UNITED STATES PATENT AND TRADEMARK OFFICE

APPLICATION NO.	FILING DATE	FIRST NAMED INVENTOR	ATTORNEY DOCKET NO.	CONFIRMATION NO.
09/802,982	03/12/2001	Stefan Karl	1200.473	6932
7590 01/21/2005				
Liniak, Berenato, Longacre & White 6550 Rock Spring Drive, Ste. 240 Bethesda, MD 20817			EXAMINER FORD, JOHN K	
			ART UNIT 3753	PAPER NUMBER

Office Action Summary

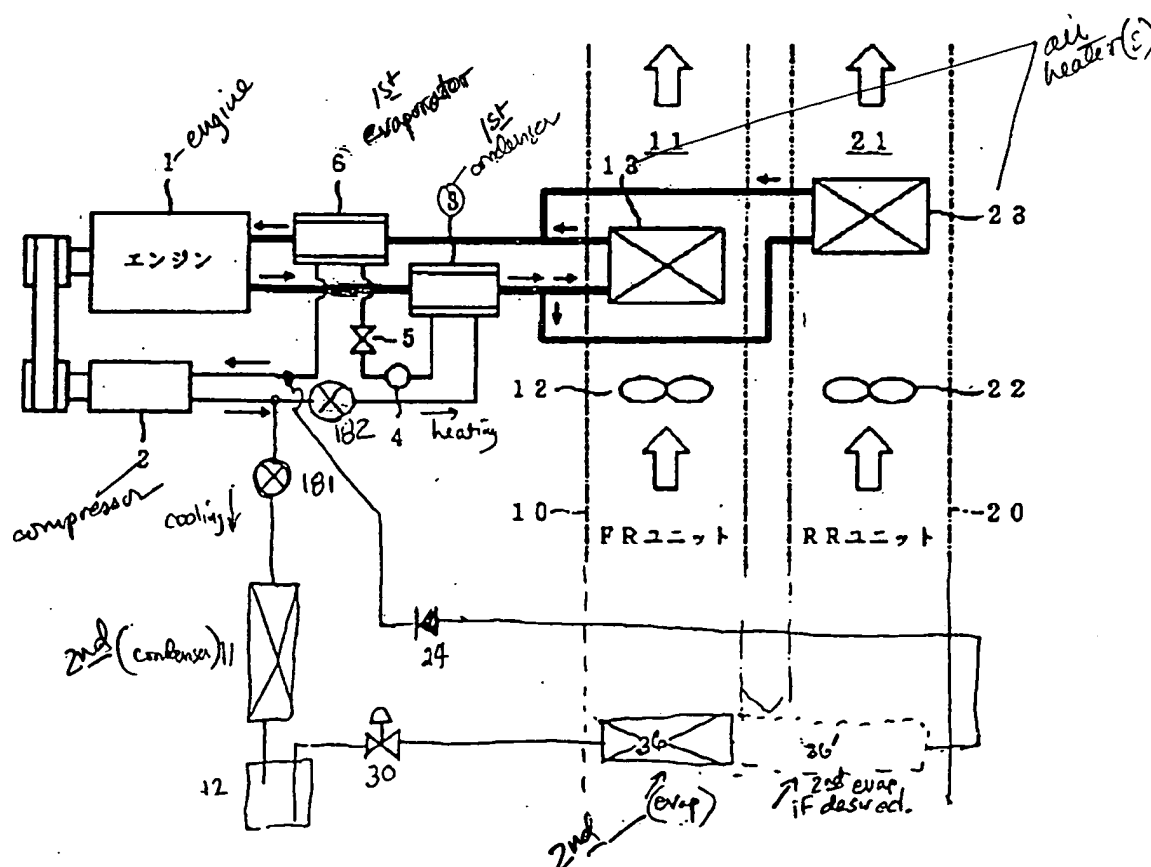
Claims 1, 2, 10, 11, 13, and 14 are rejected under 35 U.S.C. 103(a) as being unpatentable over the combined teachings of JP 10-76837 and Enomoto, Figure 8, and the description thereof.

JA '837 shows a refrigerant system for beneficially increasing the heating effect of a liquid based heating system. It has no ability to cool the compartment in hot weather. The compressor 2 is known to be the most costly component of automotive air conditioning systems.

Enomoto teaches in Figure 8 a refrigerant based heater circuit (182, 13, 37, 15) and a refrigerant based cooler circuit (181, 11, 12, 30, 36 and 24) connected in parallel across the output and inputs of the compressor 10.

To have added a refrigerant based cooler circuit (as described above) to JA '837 to give the capability of cooling in the summer as well as heating in the winter would have been obvious to one of ordinary skill in climates where air conditioning was needed to preserve occupant comfort. Appropriate valves (181, 182) on the discharge side of the compressor would be necessary to separately activate the heating and cooling systems. The modification is shown below:

Regarding claim 10, see element 24 in the sketch. Regarding claim 11, see elements 5 and 30. Regarding claims 13 and 14, not Enomoto shows an internal combustion engine and discloses as a substitute an electric motor (col.5, last line).
